Access Compliance Report

Intersection ID: 16675	Main Street: IBM_DR	Cross Street: UNIVERSTIY_POINTE_BV	Location: S
ADA ID: 22FE17A2F384	Ramp Type: Perp	Initial Pass/Fail: Fail	Overall Compliance: No
Severity Score: 1.25			
Codes/Mitigation Info/Possible Solution		Field Measurements/Component Compliance

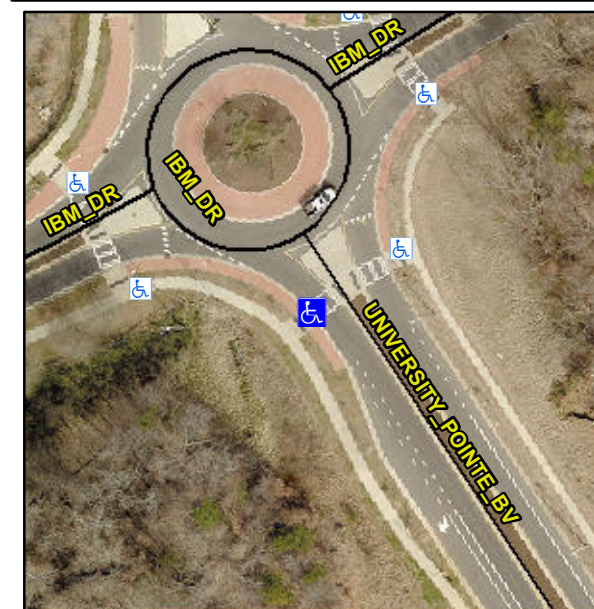
Compliance	Description	Data	Compliance	Description	Data
N/A	Ramp Length (in)	156.0	Yes	Ramp Slope (%)	5.3
Yes	Ramp Width (in)	119.0	No	Ramp XSlope (%)	2.9
N/A	Flare Type LT	N/A	N/A	Flare Type RT	N/A
N/A	Flare Slope LT (%)	N/A	N/A	Flare Slope RT (%)	N/A
N/A	Flare Traversable LT?	N/A	N/A	Flare Traversable RT?	N/A
N/A	Landing Length (in)	N/A	N/A	DWS Provided?	N/A
N/A	Landing Width (in)	N/A	N/A	DWS Contrast?	N/A
N/A	Landing Slope (%)	N/A	N/A	DWS Length (in)	N/A
N/A	Landing X Slope (%)	N/A	N/A	DWS Full Width?	N/A
N/A	Landing Curb? (Y/N)	N/A	N/A	DWS Offset (in)	N/A
N/A	Shared Landing?	N/A			
N/A	Gutter Ponding?	N/A	N/A	Gutter Slope (%)	N/A
N/A	Gutter Lip Ht (in)	2.0	N/A	Gutter X Slope (%)	N/A
N/A	Painted X Walk1?	No	N/A	Painted X Walk2?	N/A
	X Walk 1 Direction	To NE		X Walk 2 Direction	N/A
N/A	X Walk 1 Width (in)	N/A	N/A	X Walk 2 Width (in)	N/A
	X Walk 1 Slope (%)	2.6		X Walk 2 Slope (%)	N/A
	X Walk 1 X Slope (%)	4.9		X Walk 2 X Slope (%)	N/A

Remove & Replace Entire Ramp.
